CO3275 – Northfield BF 0241(58)

ADDENDUM #2

Changes have been made to the documents located on the Bid Opportunity website as noted below:

DECK REINFORCING SECTION

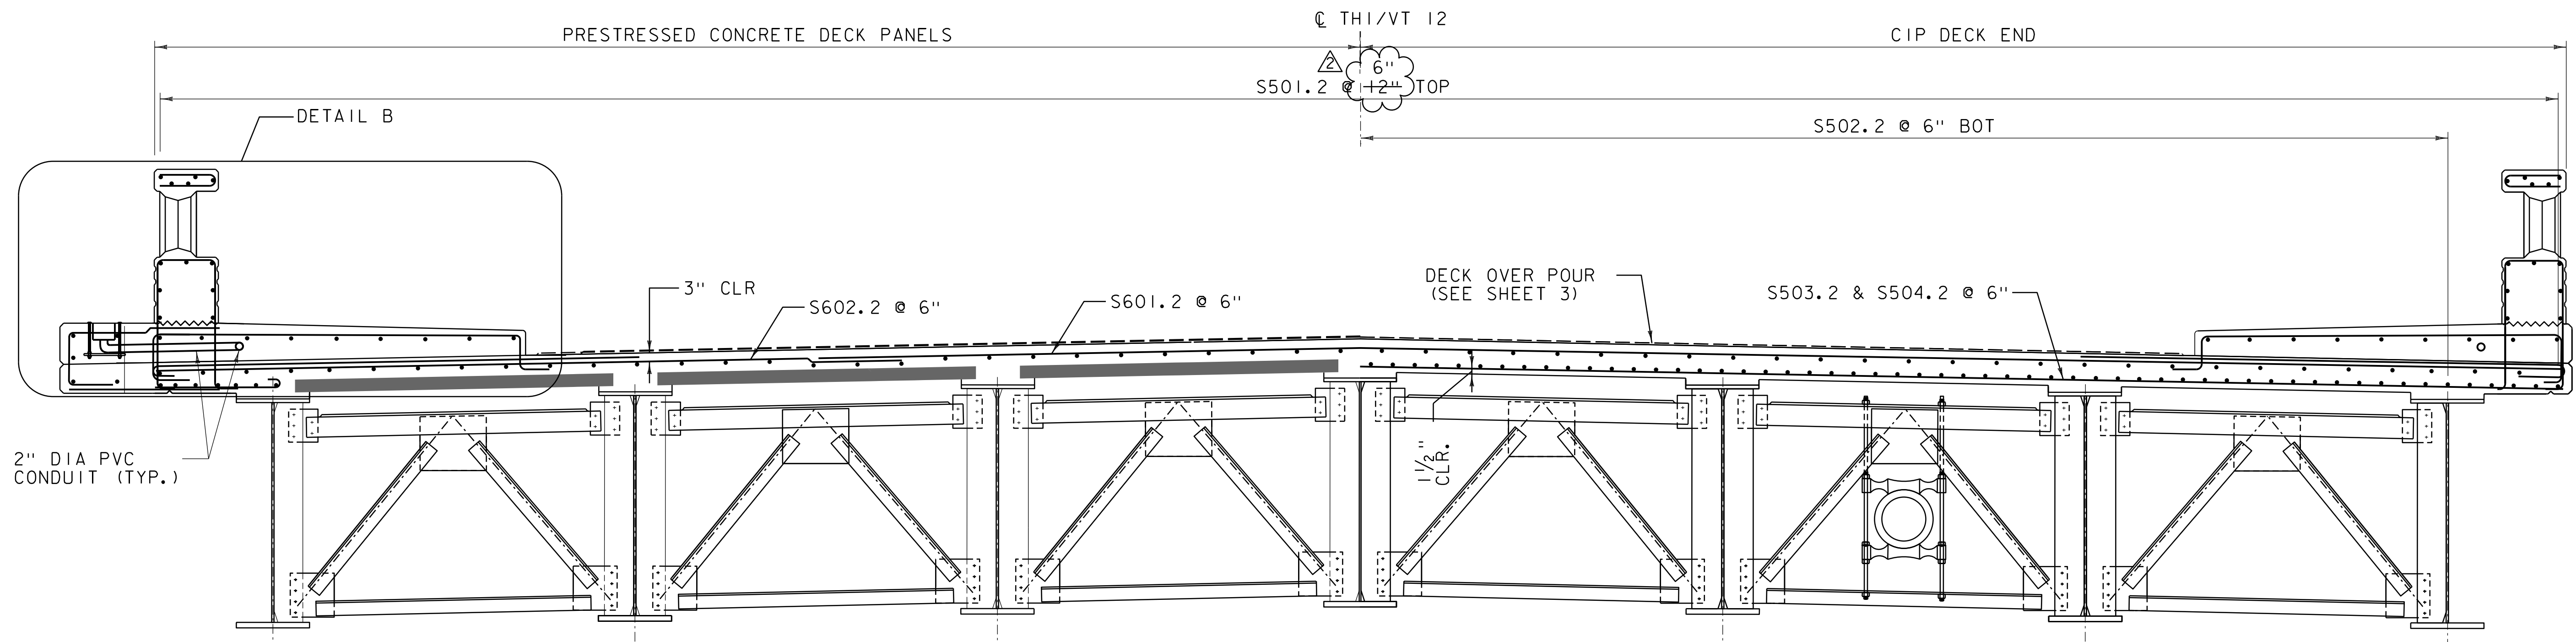
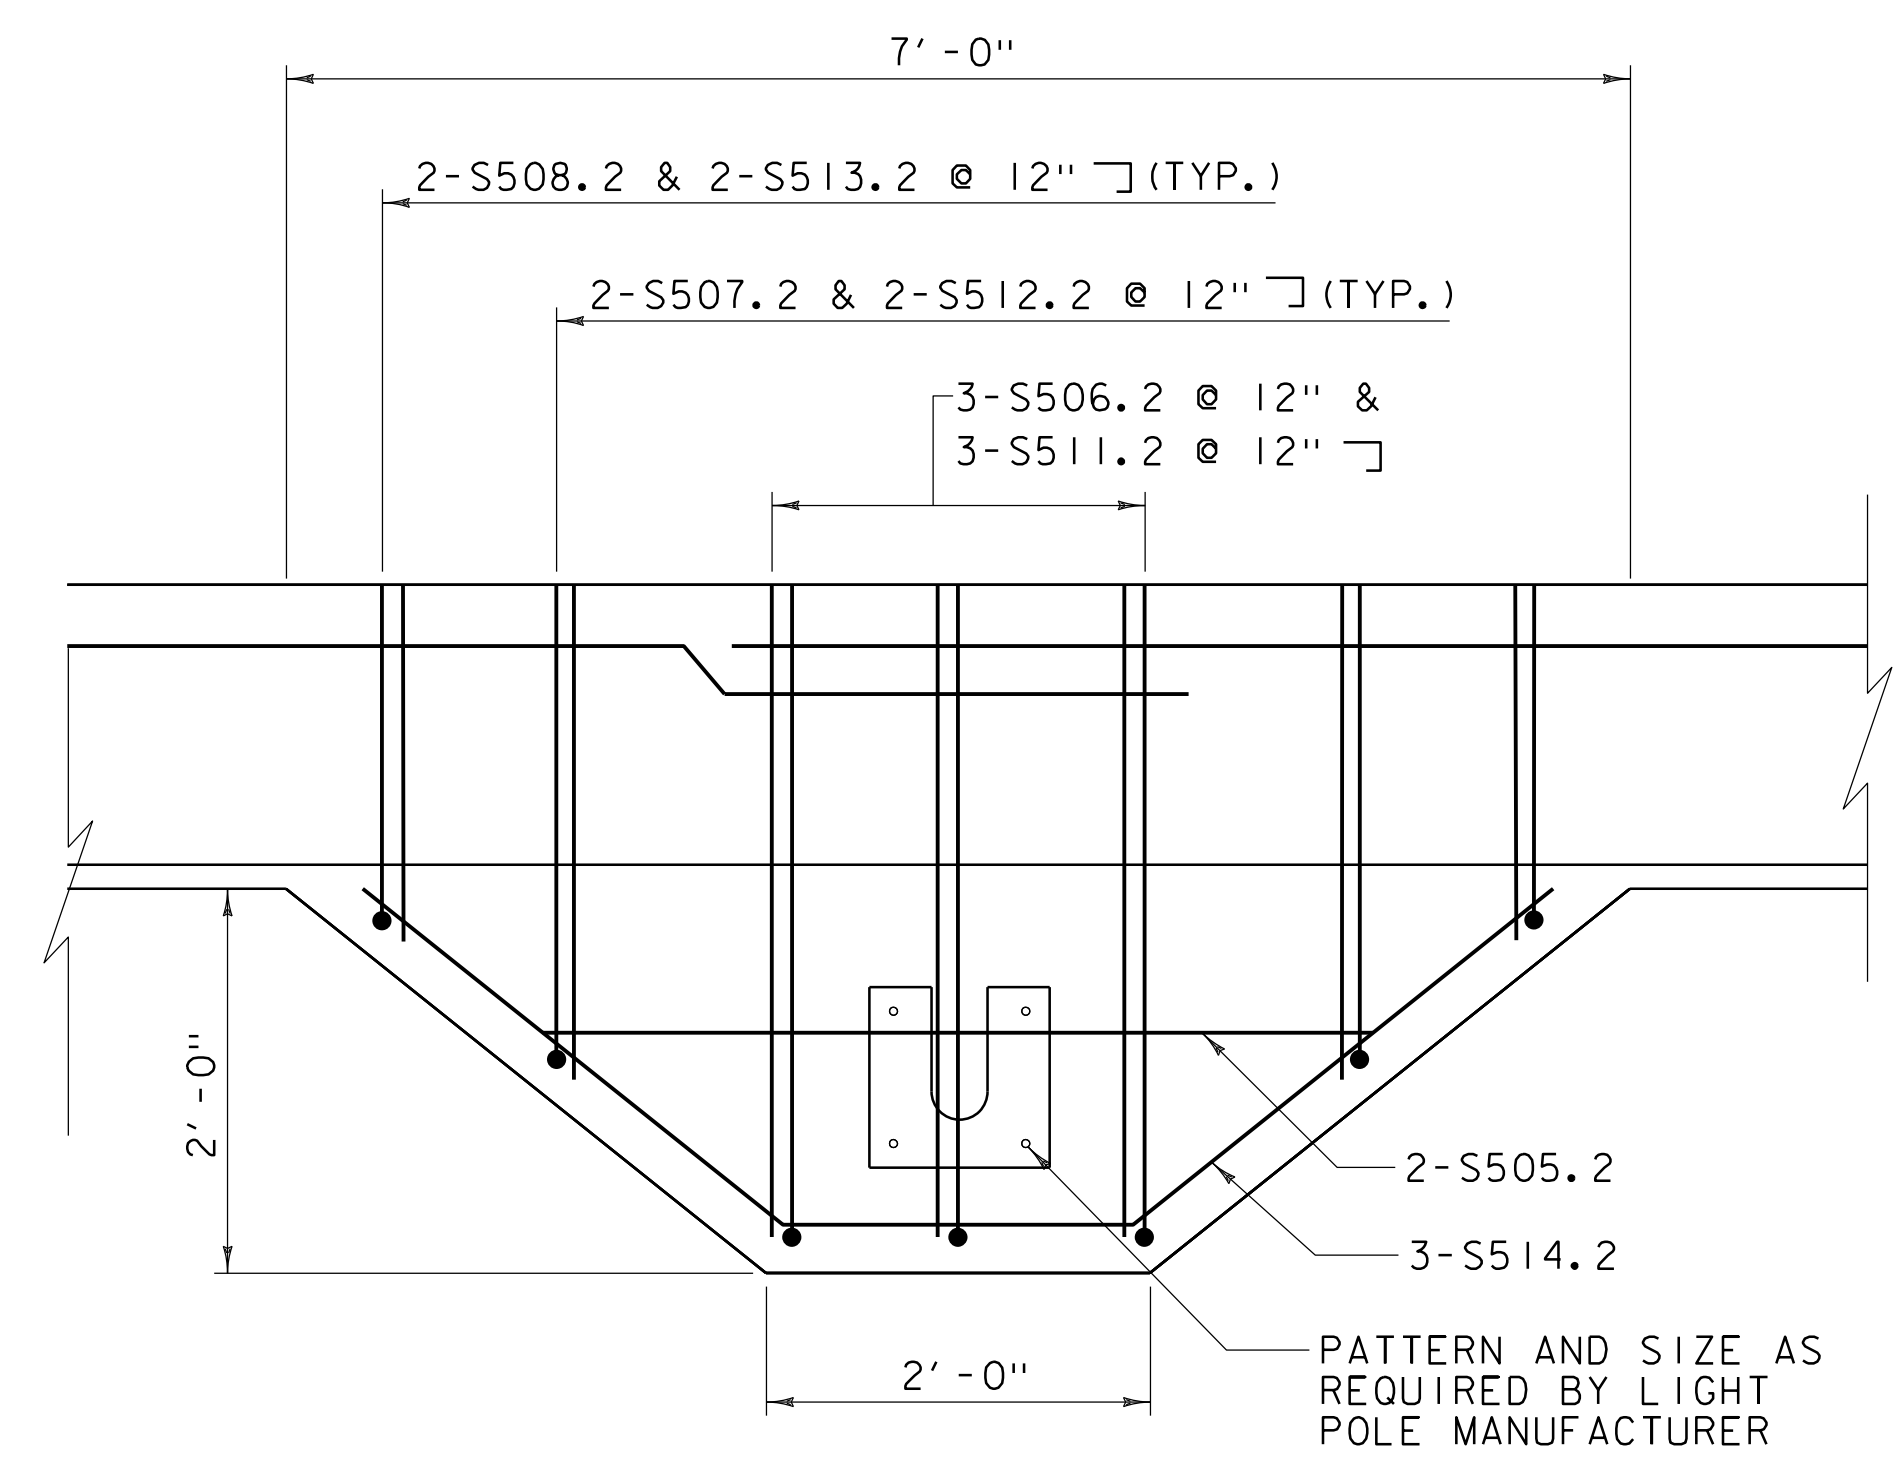
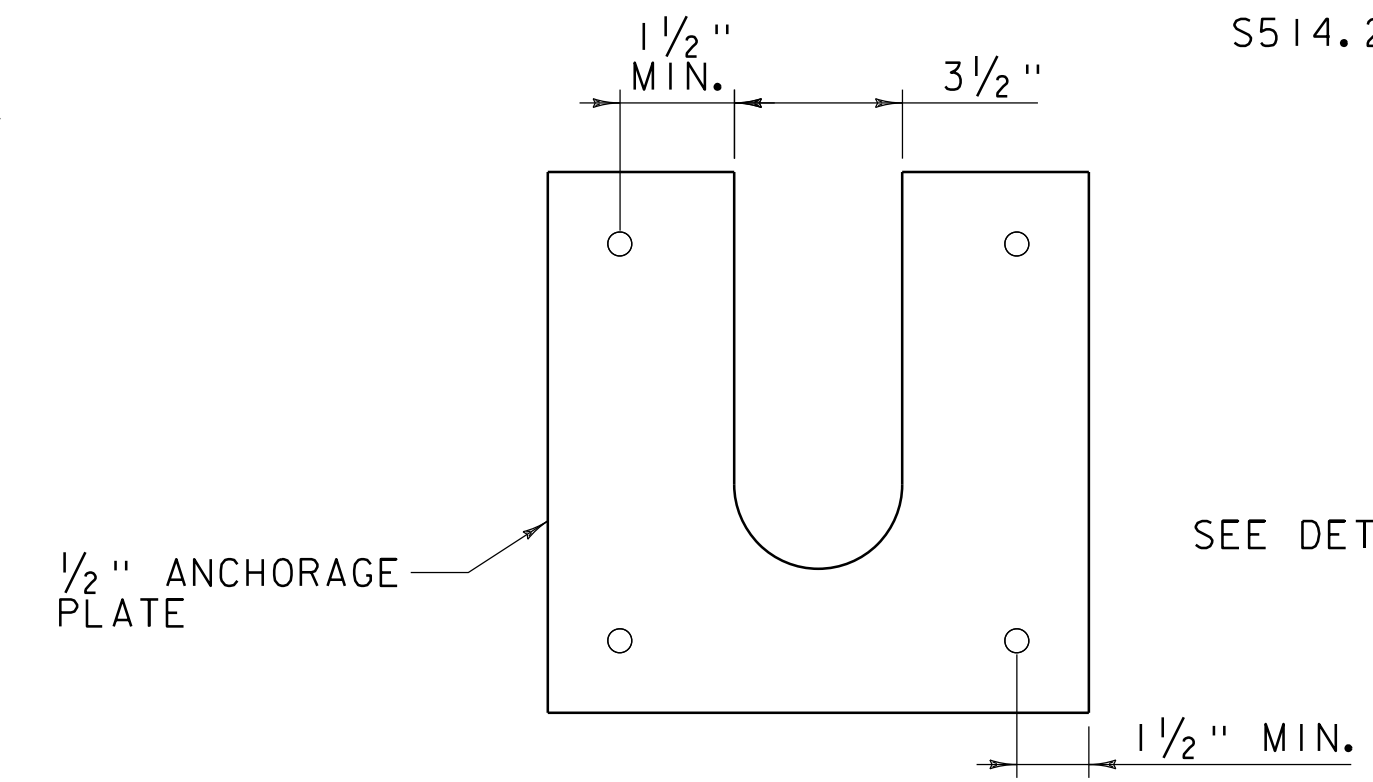
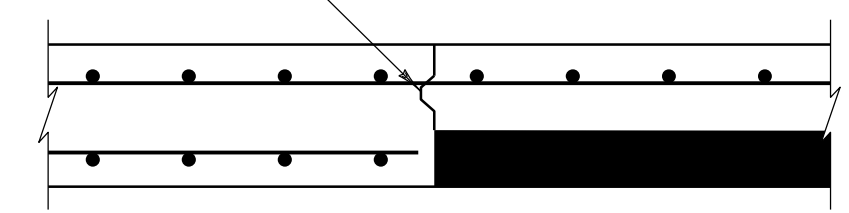
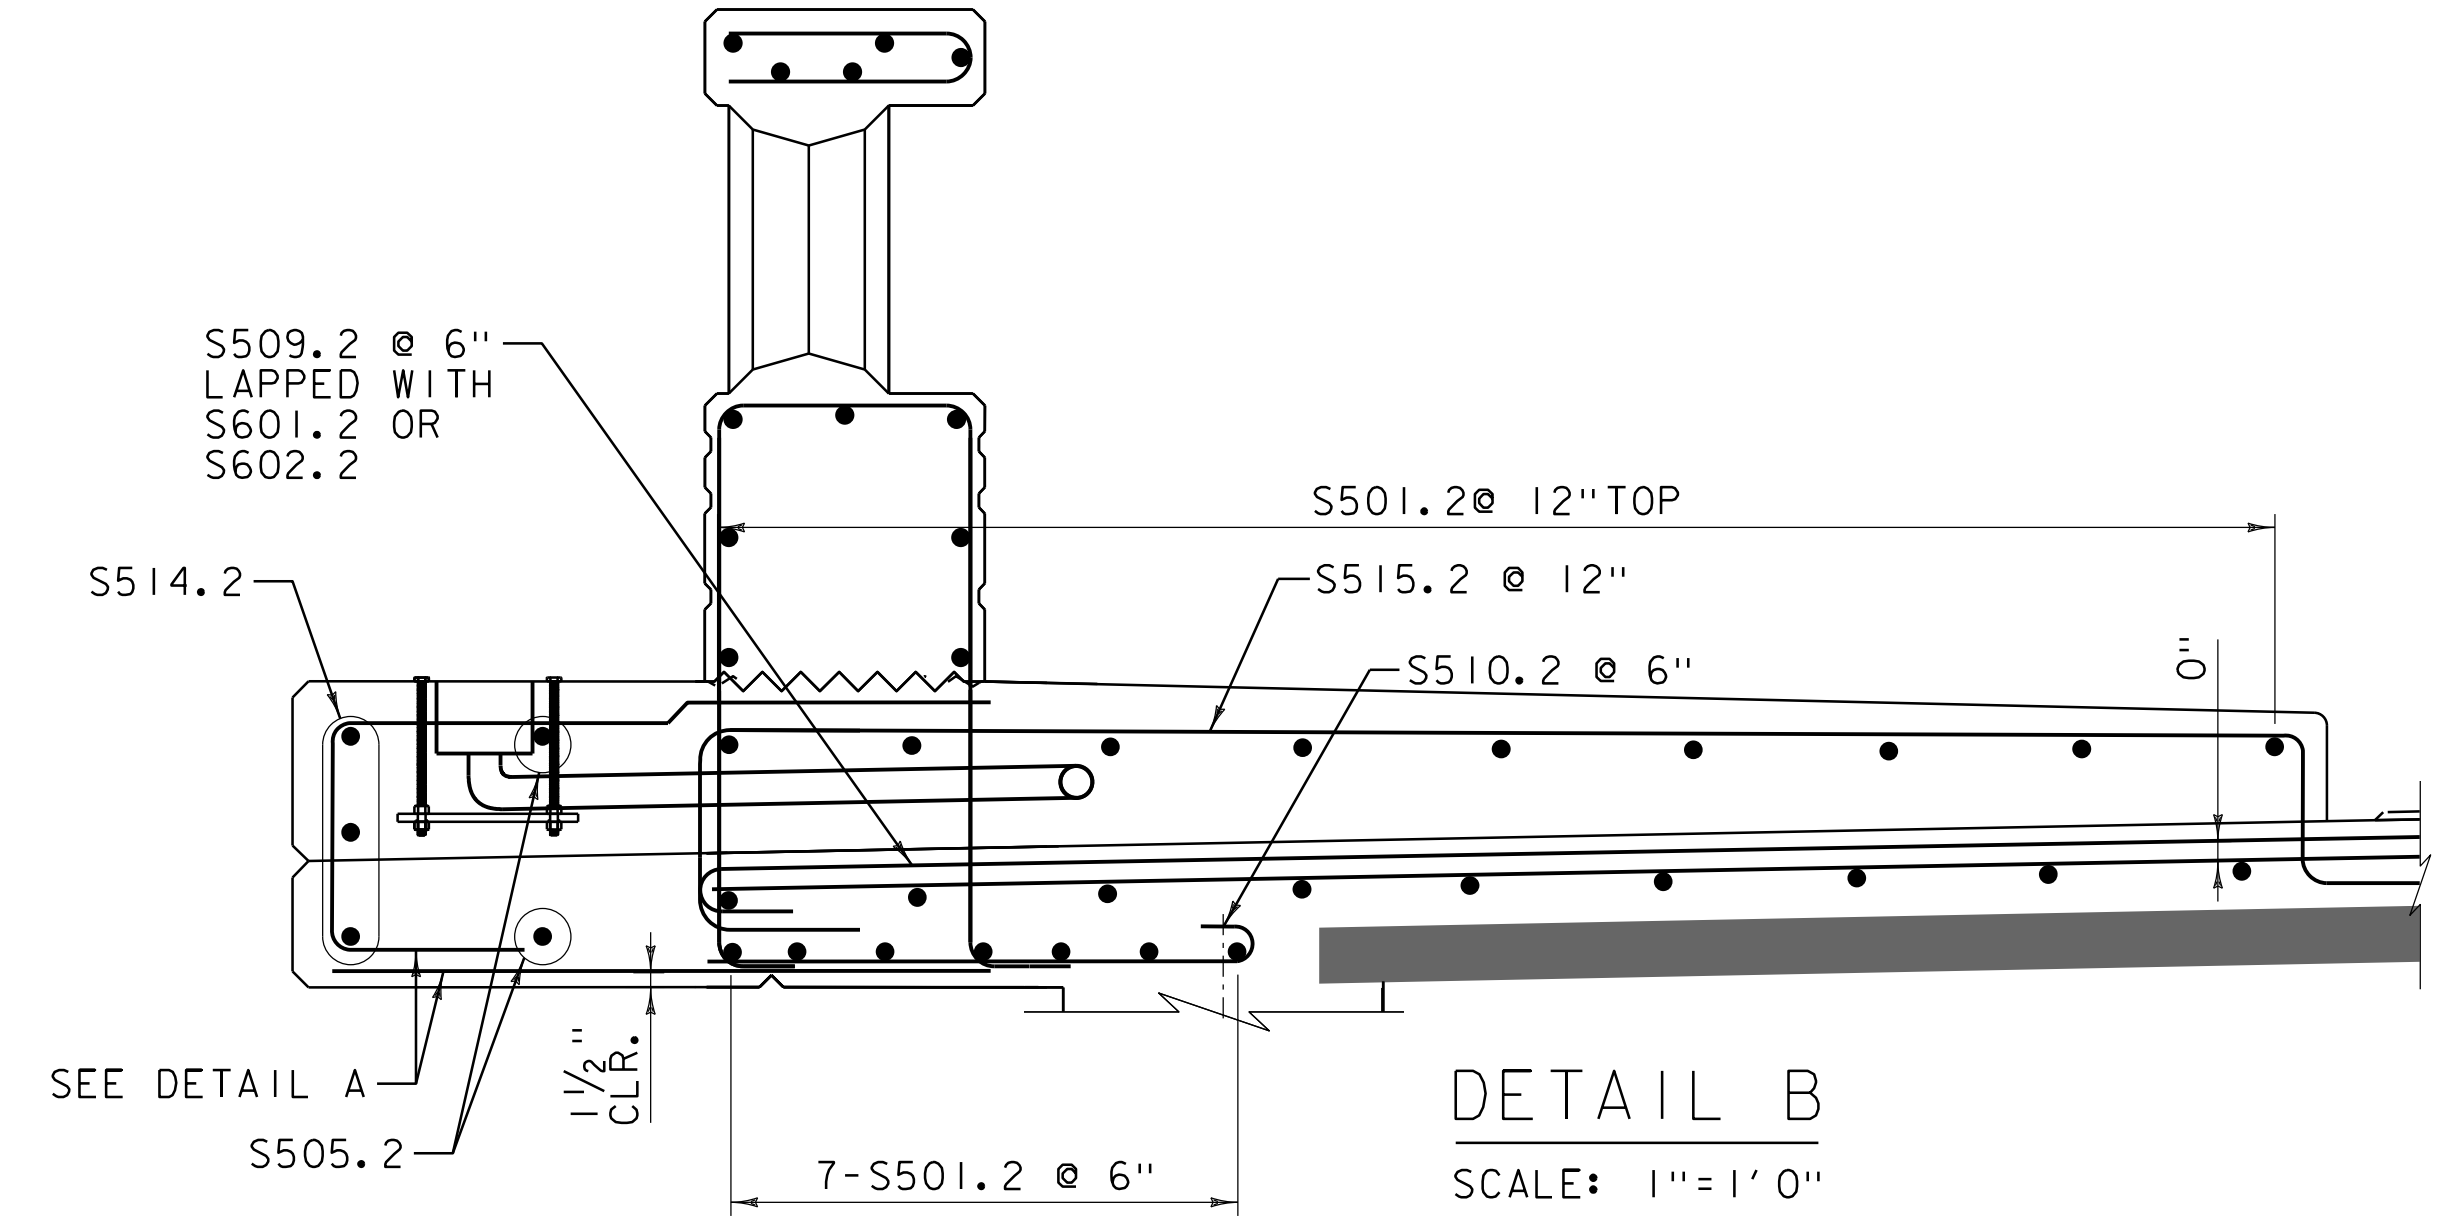
ADDENDUM	REVISION	PLOT DATE	DESCRIPTION	BY
△	I	14-MAY-2026	REINFORCING REVISED	S. BROWN
